ADDENDUM NO. 1

to
CONTRACT DOCUMENTS
for
**RENOVATIONS FOR SECURITY VESTIBULE AT
POMONA PRESCHOOL AND ARTHUR RANN ELEMENTARY SCHOOL**

for the
GALLOWAY TOWNSHIP SCHOOL DISTRICT
GALLOWAY TOWNSHIP - ATLANTIC COUNTY - NEW JERSEY

Issued: February 3, 2020

1 PARTIAL FIRST FLOOR PLAN - REMOVALS
 AD1-E01 SCALE: 1/8" = 1'-0"

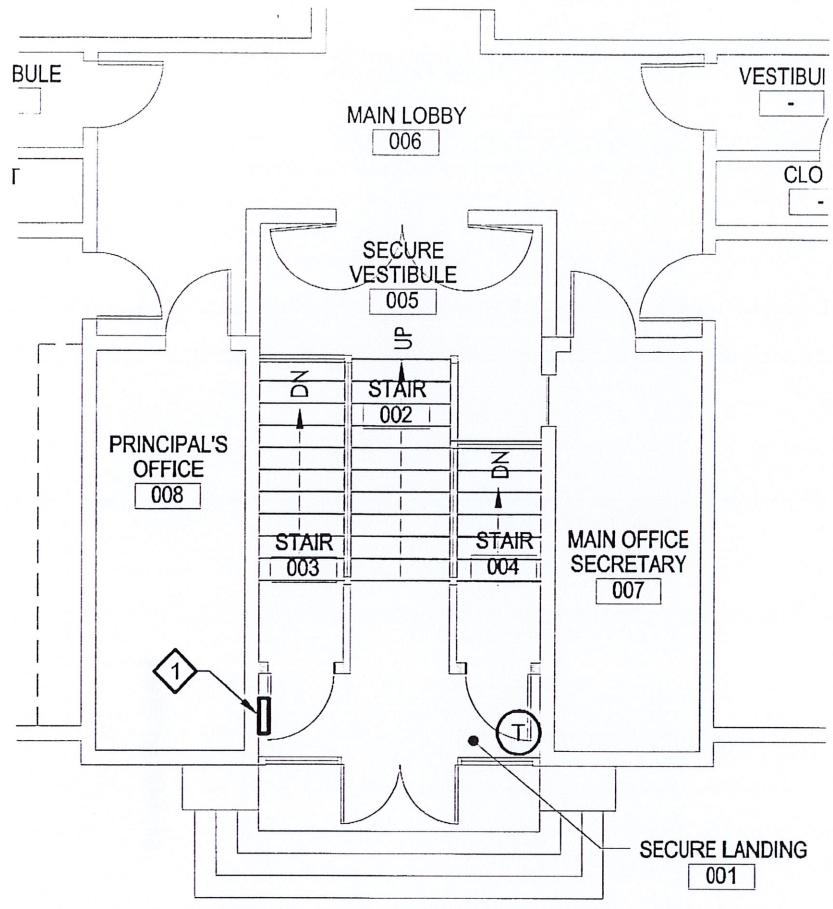
- 3.3.1.1. Remove cast iron radiator in Secure Landing 001 and provide new wall mounted electric heater. See attached sketches AD1-E01 and AD1-E02.
 - 3.3.1.2. Remove two single-pole 20-amp circuit breakers in existing panel "EPP" (Panel "EPP" located in the Main Electrical Room) and turn over to the Owner. Provide one 2-pole 20-amp circuit breaker in Panel "EPP." Provide a 2-pole 30-amp disconnect switch for the electric heater. Provide (2)#12,(1)#12G, 3/4" C from the new circuit breaker and wire through the new disconnect switch and connect to the new electric heater. Provide wiring in conduit raceway or MC cable in concealed locations. Provide wiring in surface mounted raceway painted to match the existing wall finish in exposed locations.

REMOVAL NOTES:

- 1 REMOVE CAST IRON RADIATOR AND ITS WOODEN ENCLOSURE. REMOVE PIPING TO A POINT BEHIND EXISTING CONSTRUCTION AND CAP. PATCH EXISTING CONSTRUCTION TO MATCH EXISTING.

1 PARTIAL FIRST FLOOR PLAN - NEW WORK
 AD1-E02 SCALE: 1/8" = 1'-0"

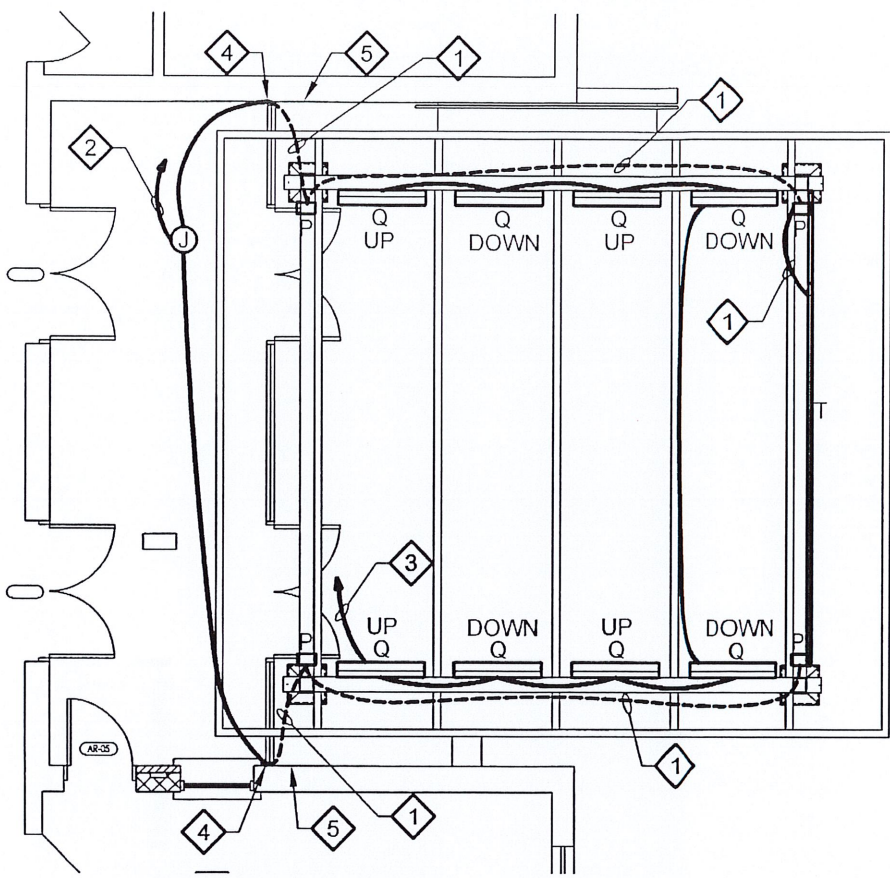
NEW WORK NOTES:

- 1** PROVIDE NEW, WALL MOUNTED ELECTRIC HEATER. BASIS OF DESIGN IS BERKO MODEL QFF4007, 240 VAC, 3 KW WITH SURFACE MOUNTING FRAME AND LINE VOLTAGE THERMOSTAT. WIRE THERMOSTAT IN ACCORDANCE WITH THE HEATER MANUFACTURER'S INSTRUCTIONS. COMPARABLE HEATER FROM OTHER MANUFACTURERS MAY BE SUBMITTED FOR REVIEW. SECURE HEATER TO WALL AT APPROXIMATELY 7.5 FEET ABOVE FINISHED FLOOR. COORDINATE FINAL LOCATION WITH ARCHITECT.

Drawing Number
AD1-E04

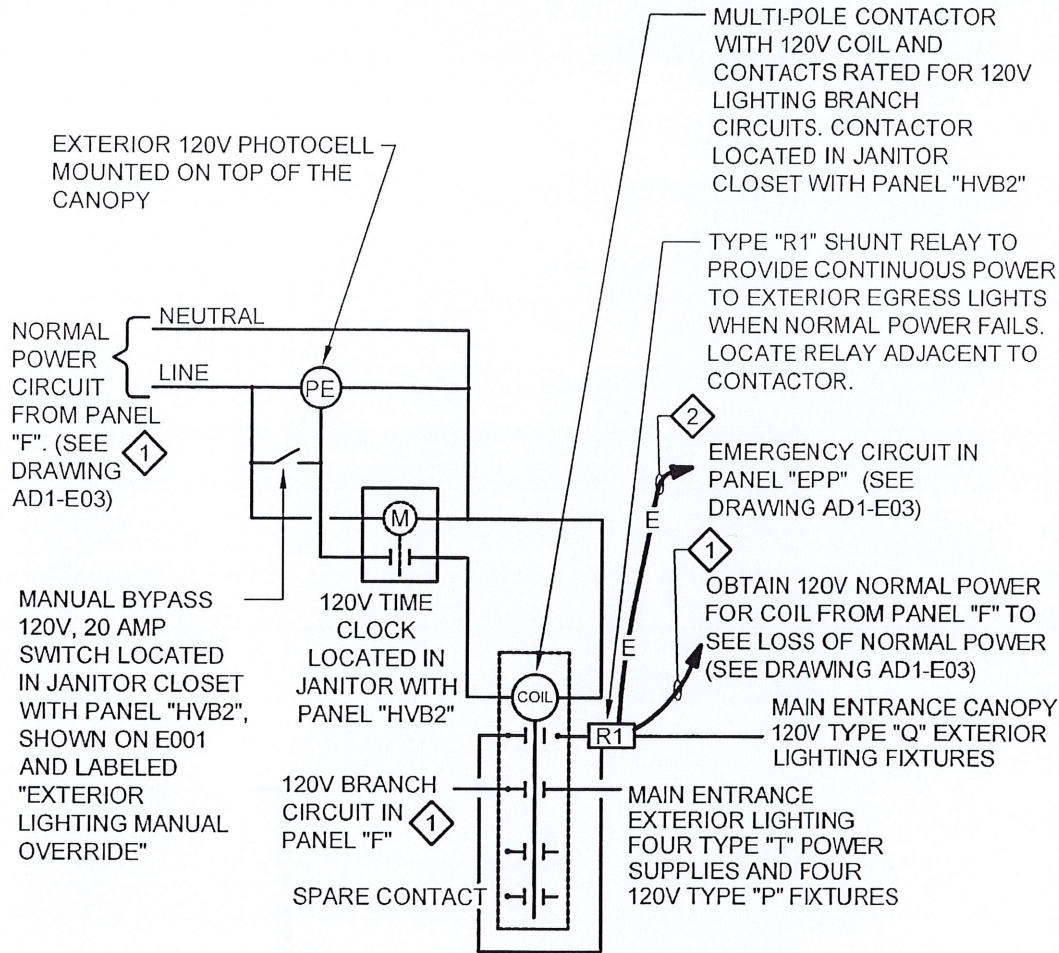
NEW WORK NOTES:

(APPLIES ONLY TO DRAWING AD1-E03)

- 1 COORDINATE THE EXACT LOCATION, LENGTH, AND NUMBER OF THE REQUIRED TYPE "T" LED TAPE LIGHT FIXTURES AND THE EXACT NUMBER OF POWER SUPPLIES WITH THE MANUFACTURER, ARCHITECT, AND GENERAL CONTRACTOR FOR A COMPLETE INSTALLATION AS SHOWN ON THE ARCHITECTURAL DRAWINGS PRIOR TO PURCHASING THE FIXTURES AND POWER SUPPLIES. WIRE THE LOW VOLTAGE EXTERIOR LED LIGHT FIXTURES TO THEIR REQUIRED LOW VOLTAGE DRIVER/120VACxLV-DC POWER SUPPLIES (LOCATE POWER SUPPLIES IN A WEATHERPROOF EXTERIOR ENCLOSURE CONCEALED IN THE CANOPY). COORDINATE THE ENCLOSURE LOCATION WITH THE ARCHITECT PRIOR TO THE START OF WORK. TYPE "P" FIXTURES ARE TO BE SURFACE MOUNTED ON CANOPY COLUMNS. COORDINATE THE EXACT NUMBER AND MOUNTING LOCATIONS OF THE LIGHT FIXTURES WITH THE ARCHITECT PRIOR TO THE START OF ANY WORK. THE BRANCH CIRCUITS FOR THE TYPE "P" AND "T" FIXTURES SHALL EXTEND DOWN THROUGH THE COLUMNS (ROUTE BETWEEN THE STEEL COLUMN AND CSMU OF COLUMN ENCLOSURE) AND UNDERGROUND TO THE BUILDING. REFER TO THE ARCHITECTURAL DRAWING DETAILS AND COORDINATE WITH THE ARCHITECT FOR THE EXACT UNDERGROUND AND ABOVE GROUND ROUTING OF THE BRANCH CIRCUIT RACEWAYS PRIOR TO THE START OF ANY WORK. PAINT THE BRANCH CIRCUIT CONDUITS TO MATCH THE ADJACENT STEEL STRUCTURE (COLOR SELECTED BY ARCHITECT). EXTEND 120V WIRING FROM THE POWER SUPPLIES TO AN INTERIOR JUNCTION BOX TO POWER THE TYPE "T" AND "P" FIXTURES FROM THE SAME PANEL "F" 120V BRANCH CIRCUIT CONTROLLING THE SHUNT RELAYS FOR THE VESTIBULE LIGHTING. REFER TO 1/AD1-E05 FOR MORE INFORMATION.

- 2 WIRE TO EXTERIOR LIGHTING CONTROL SHOWN ON 1/AD1-E05.
- 3 SEE THE EXTERIOR LIGHTING CONTROL DETAIL ON 1/AD1-E05 FOR BRANCH CIRCUIT POWER AND EMERGENCY LIGHTING CONTROL SHUNT RELAY REQUIREMENTS. REFER TO THE ARCHITECTURAL DRAWING DETAILS AND COORDINATE WITH THE ARCHITECT FOR THE EXACT ROUTING OF THE BRANCH CIRCUIT RACEWAYS FROM THE EXTERIOR LIGHT FIXTURES AND INTO THE BUILDING PRIOR TO THE START OF ANY WORK. ROUTE THE BRANCH CIRCUITS BETWEEN THE STEEL COLUMN AND CSMU OF COLUMN ENCLOSURE AND UNDERGROUND TO THE BUILDING. PAINT THE BRANCH CIRCUIT CONDUITS TO MATCH THE ADJACENT STEEL STRUCTURE (COLOR SELECTED BY ARCHITECT).

- 4 PROVIDE SURFACE MOUNTED WIRE RACEWAY TRANSITIONING FROM THE UNDERGROUND CONDUIT TO ABOVE THE DROPPED CEILING.
- 5 IN LIEU OF ORIGINAL BID DOCUMENT PLAN 2/E100AR, THE EXISTING WALL MOUNTED LIGHT FIXTURE SHOWN REMOVED ON PLAN 1/E100AR WILL NOT BE REINSTALLED. AFTER TURN THE LIGHT FIXTURES OVER TO THE OWNER AND PROVIDE COVER PLATES PAINTED TO MATCH THE EXISTING WALL FINISH.

1 EXTERIOR LIGHTING CONTROL DIAGRAM
 AD1-E05 SCALE: NONE

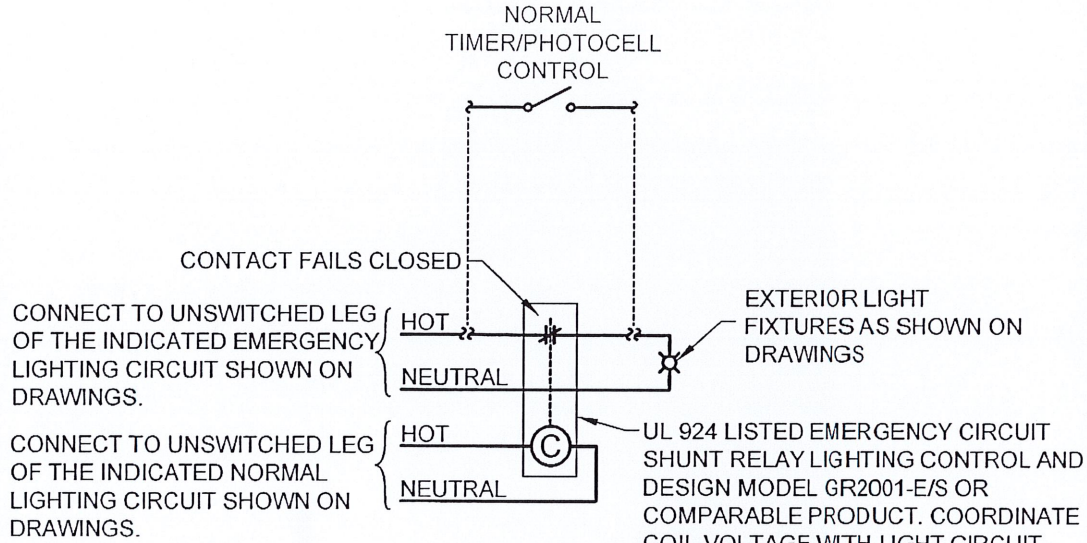
NEW WORK NOTES:

- 1 INTERCEPT AND EXTEND THE 120V BRANCH CIRCUIT FROM EXISTING PANEL "F" (USED FOR NORMAL CONTROL POWER OF THE VESTIBULE LIGHTING CONTROL SHUNT RELAY SHOWN ON PLAN 2/E100AR), FOR LIGHTING CONTROL AND POWER AS SHOWN ON AD1-E03 AND AD1-E05.
- 2 INTERCEPT AND EXTEND THE 120V BRANCH CIRCUIT FROM EXISTING PANEL "EPP" (USED FOR EMERGENCY POWER OF THE VESTIBULE LIGHTING CONTROL SHUNT RELAY SHOWN ON PLAN 2/E100AR), FOR LIGHTING POWER, AS SHOWN ON AD1-E03 AND AD1-E05.
